To: All Prospective Bidders
Re: Plyler Park Renovation
Date: January 2018

We would like to take this opportunity to inform you that the Plyler Park Renovation Invitation for Bid (IFB #18-B0073) has been cancelled in its entirety. We would also like to inform you that a new Invitation for Bid (IFB #18-B0094) for the Plyler Park Renovation project has been created. The Plyler Park Renovation Drawings, Addenda 1 thru 8 and revised Specifications associated with IFB #18-B0073, as well as this Cover Sheet outlining applicable information, shall hereby be incorporated and be made part of this current Invitation for Bid (IFB #18-B0094).

Plyler Park Renovation

Questions and Answers
Pre-Bid Conference for Plyer Park Renovation
December 8, 2017

ALTERNATE 2 - CONCRETE

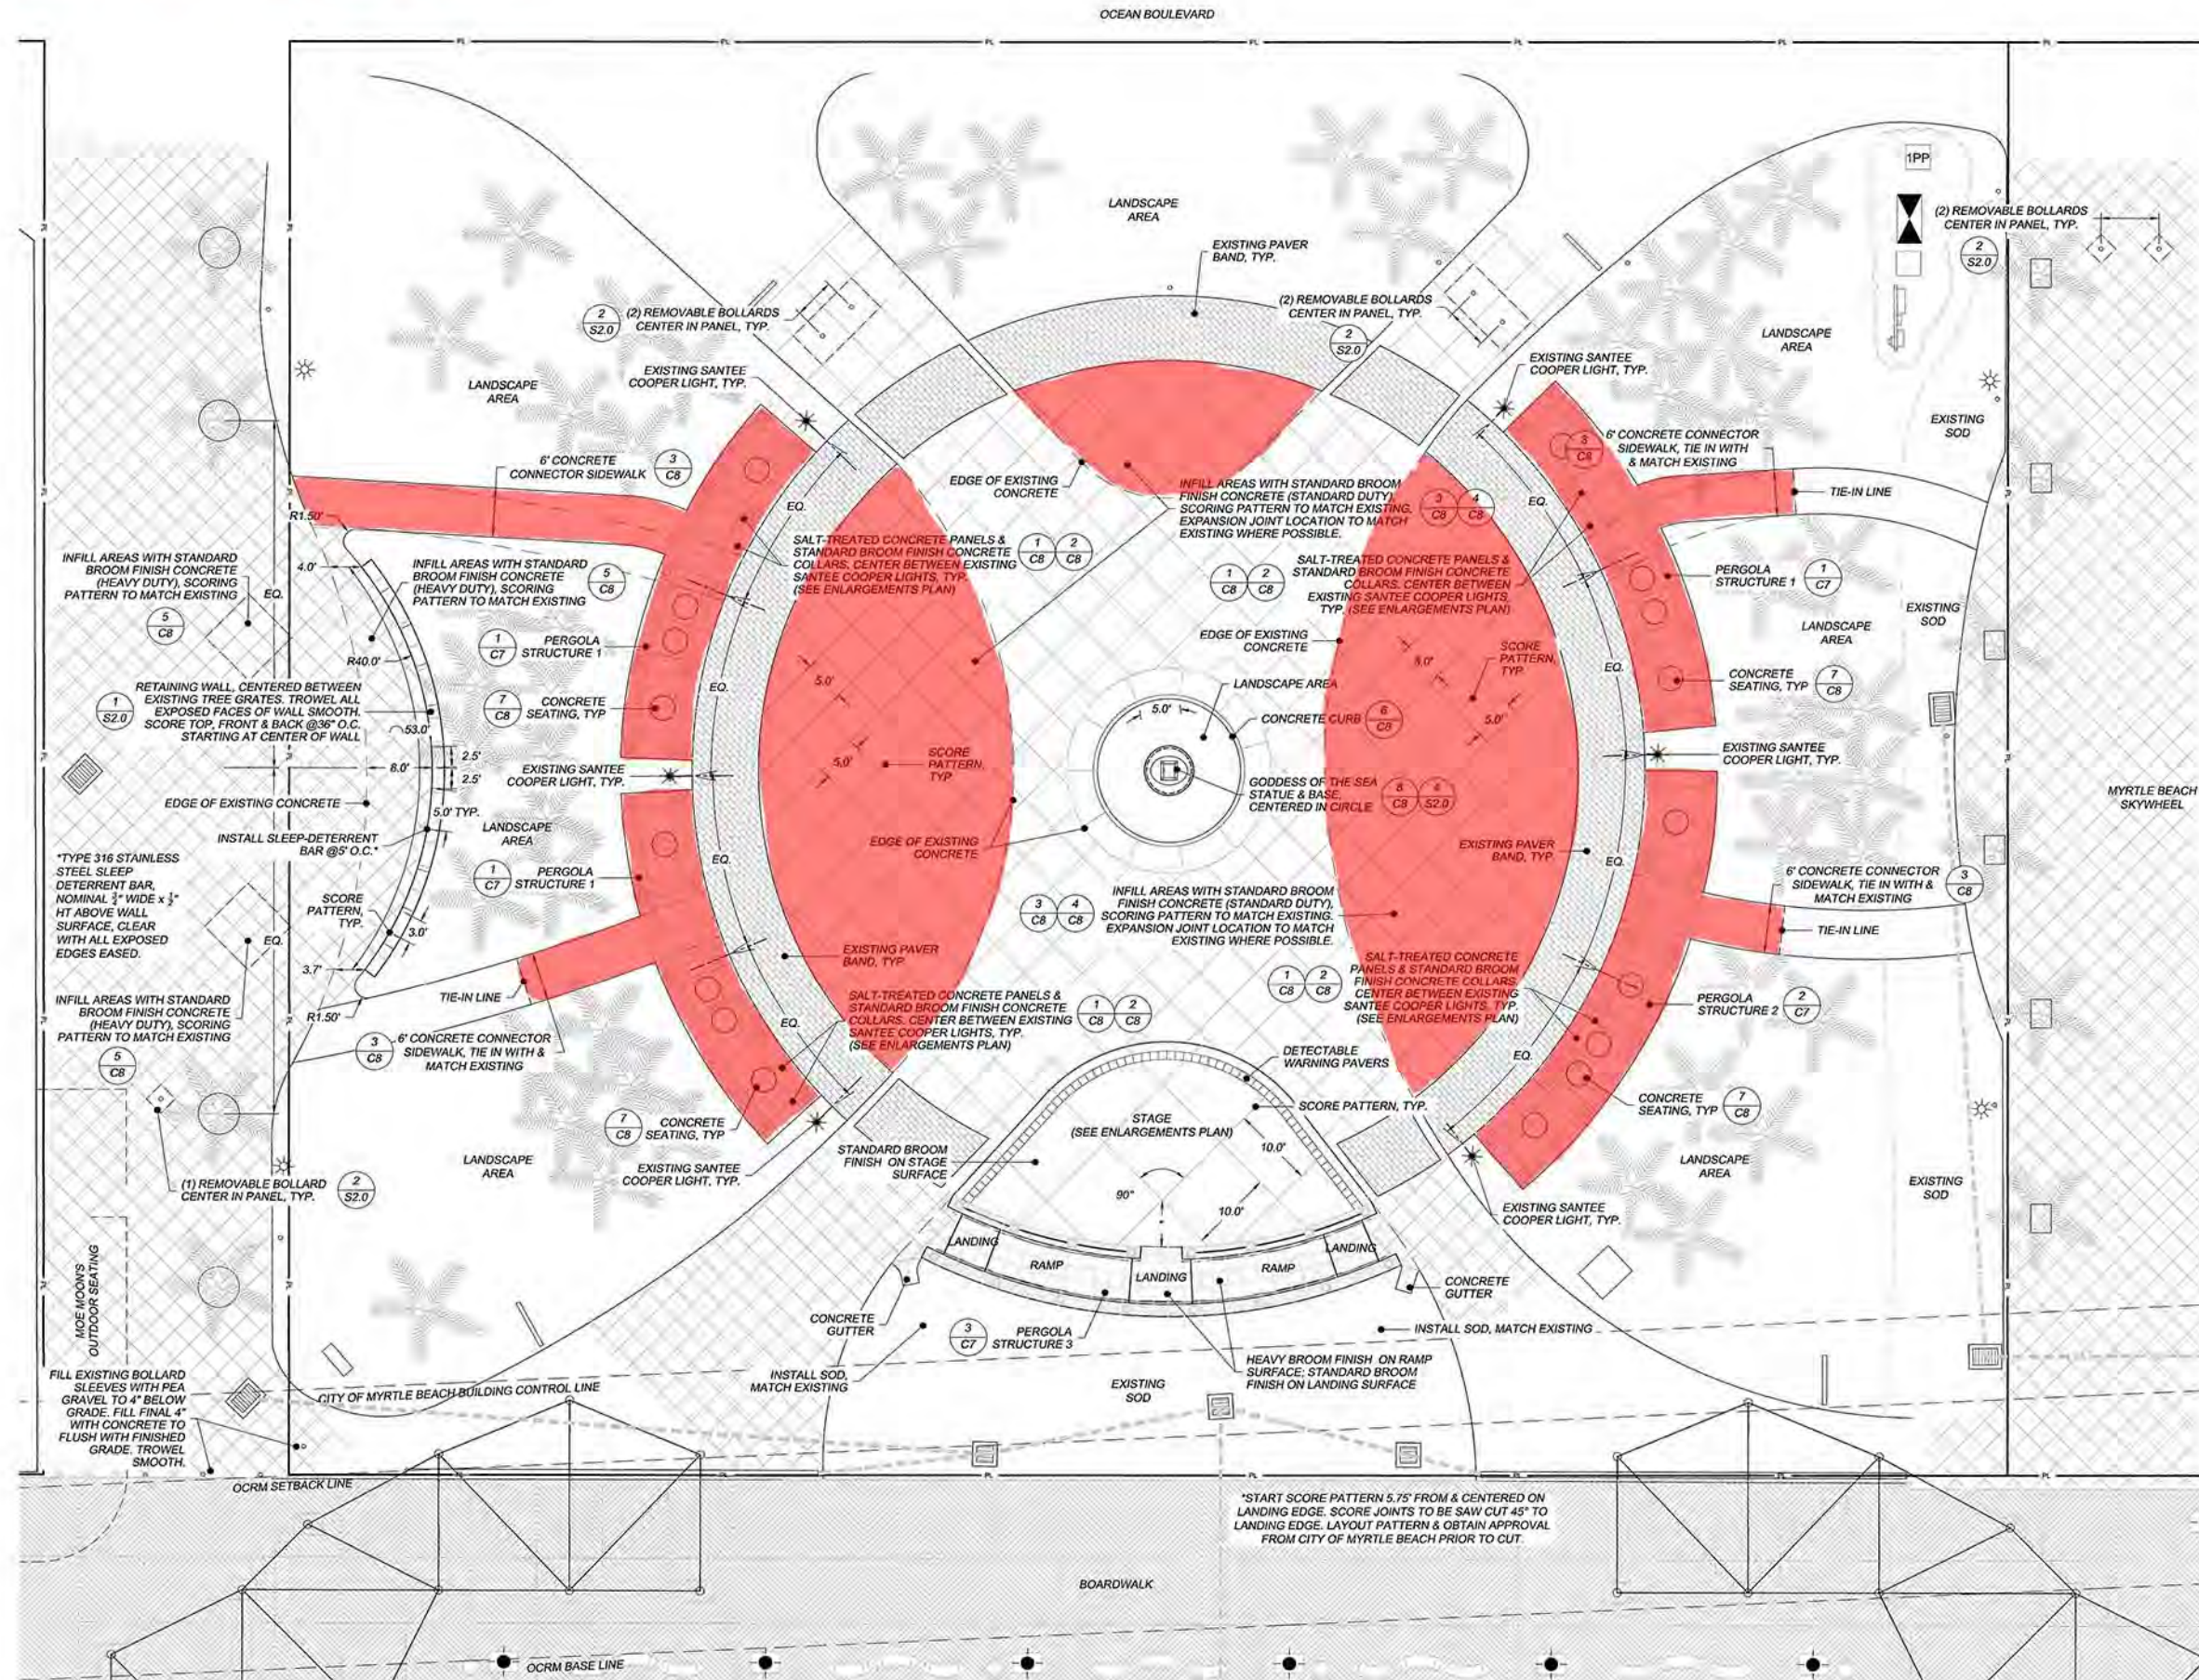
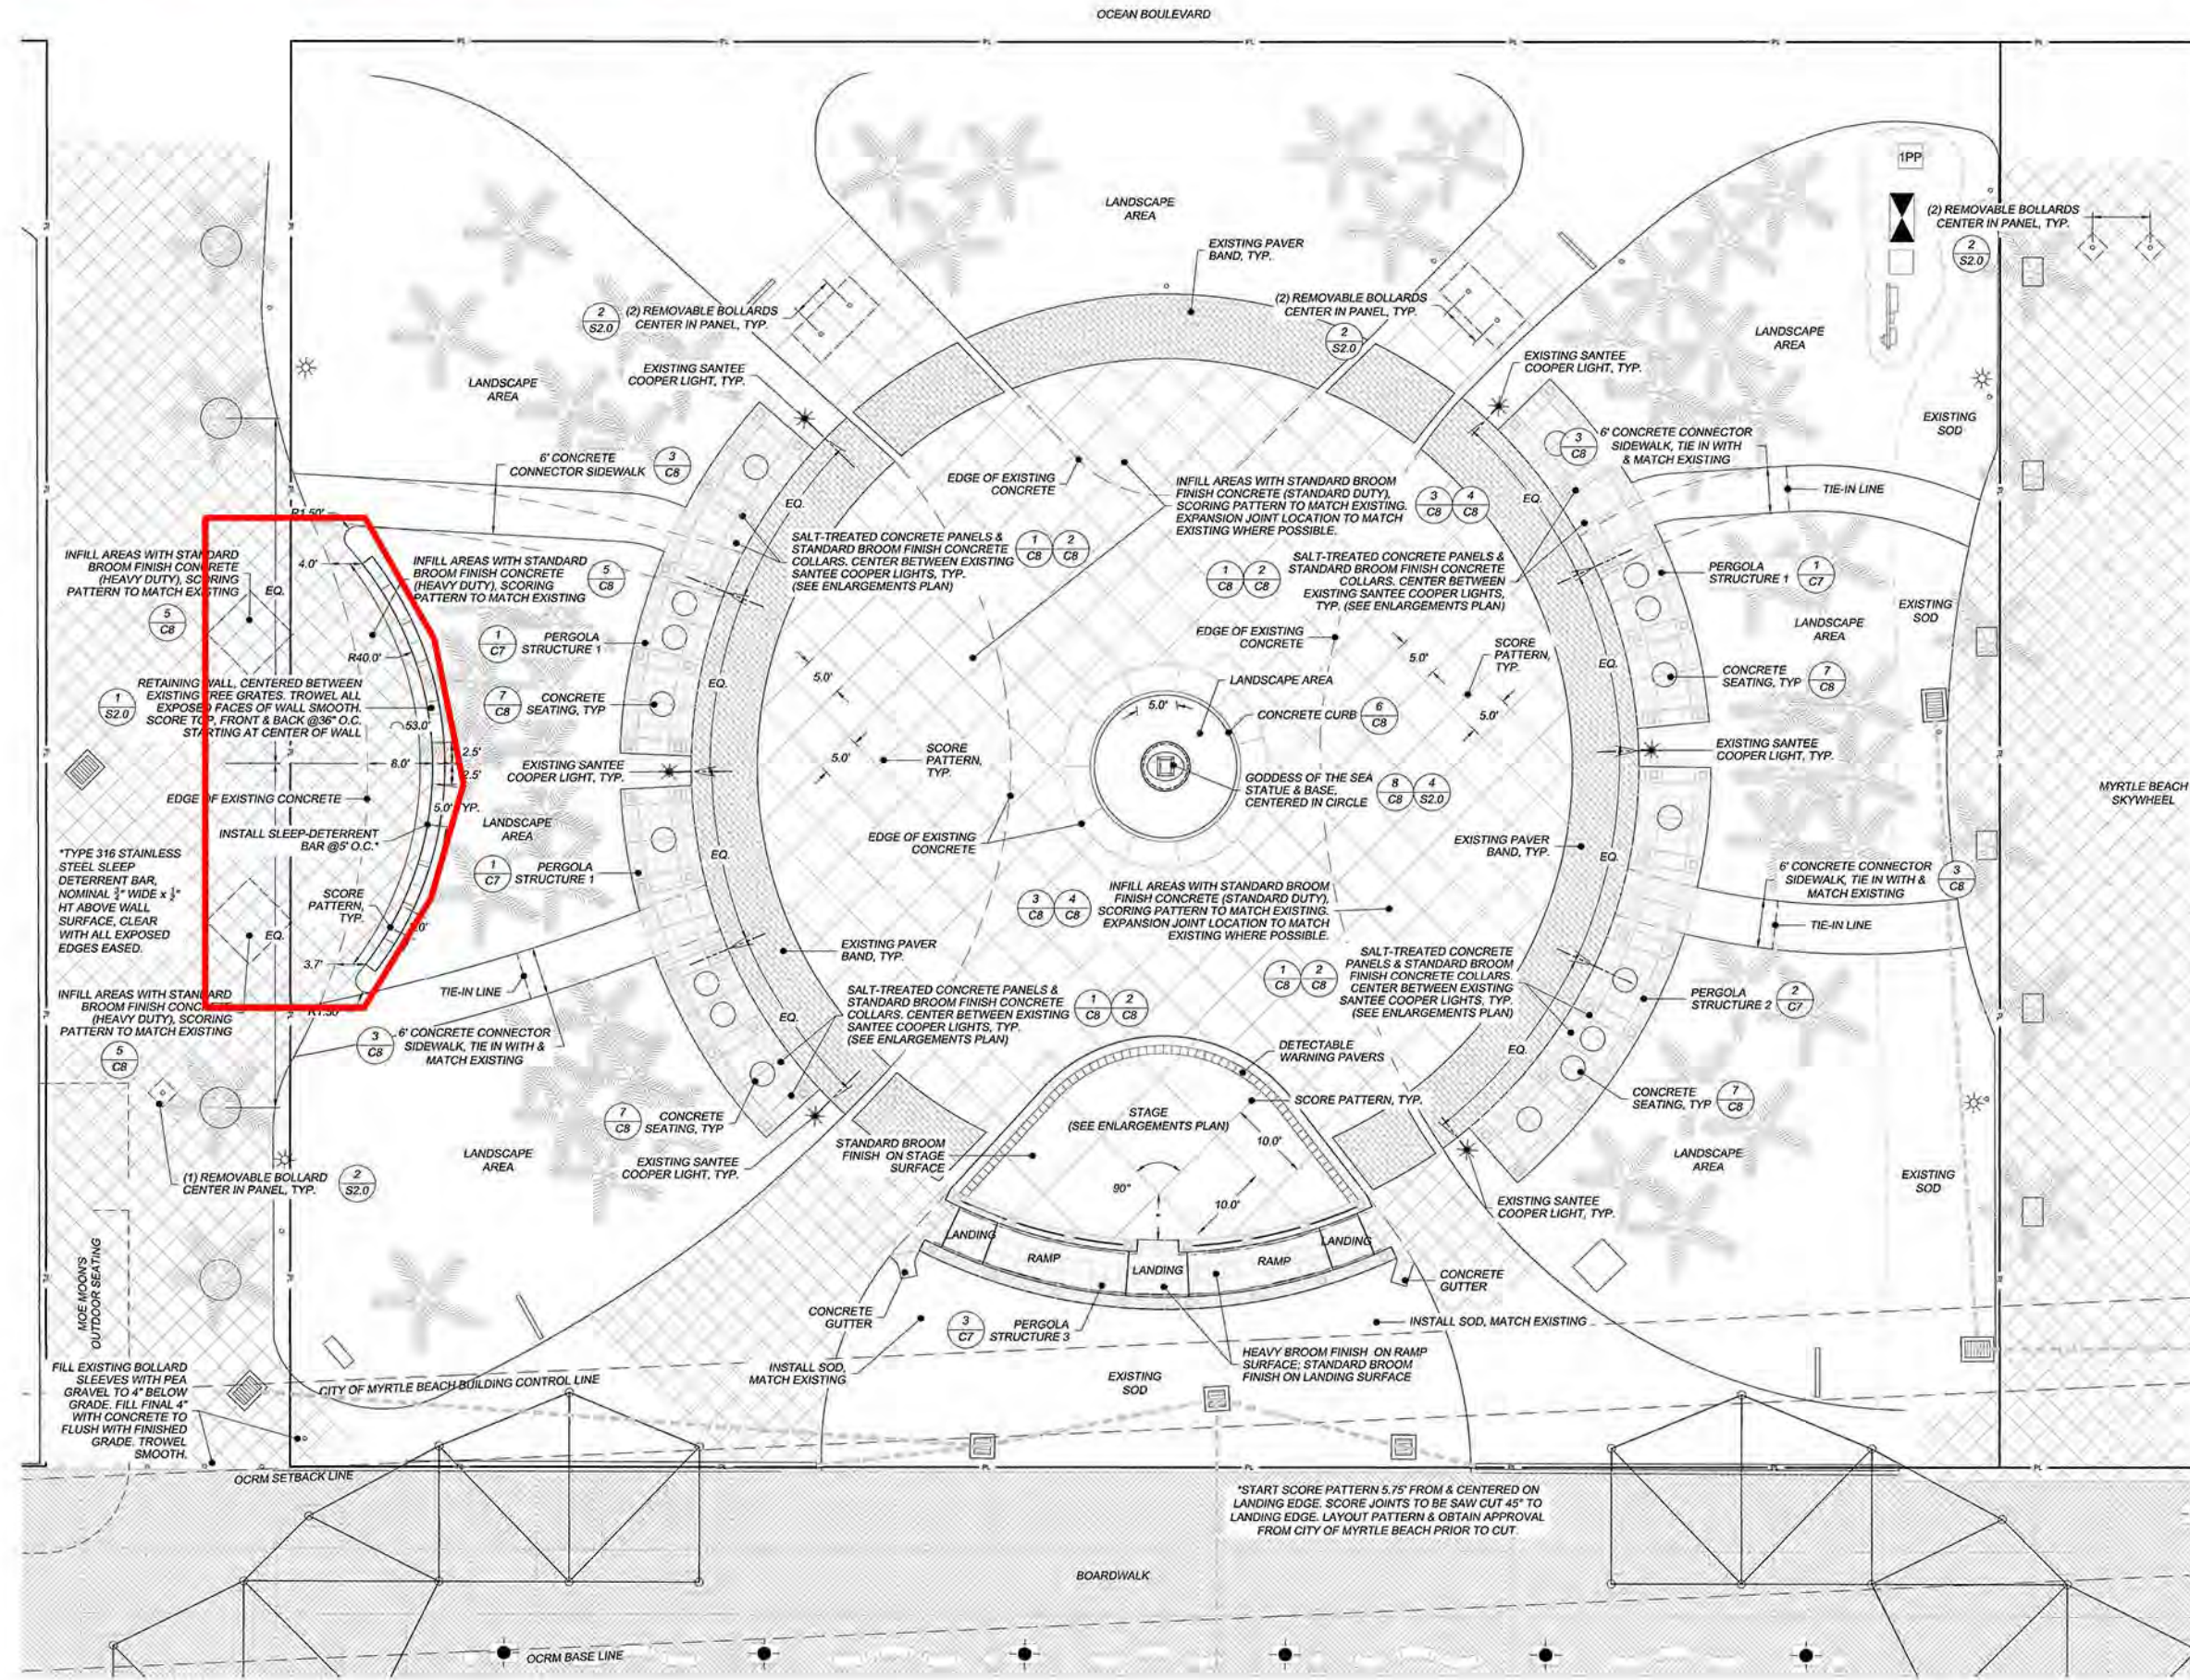
5. Q: Landscaping - No plans to tell us what to plant.

Please see attached for L1, L2 and the revised irrigation sheets. Also, see revised plan and notes on E1.0 and attachment for fixture specification. Fixture shall be 18W 4000K color temperature with black finish. Contractor shall replace existing Drawing and Addendum #3 clarification item with the revised Drawing.

A: No plant material, with the exception of a small amount of sod behind the stage, is included in this contract. Please refer to C4 for direction in the landscape areas.
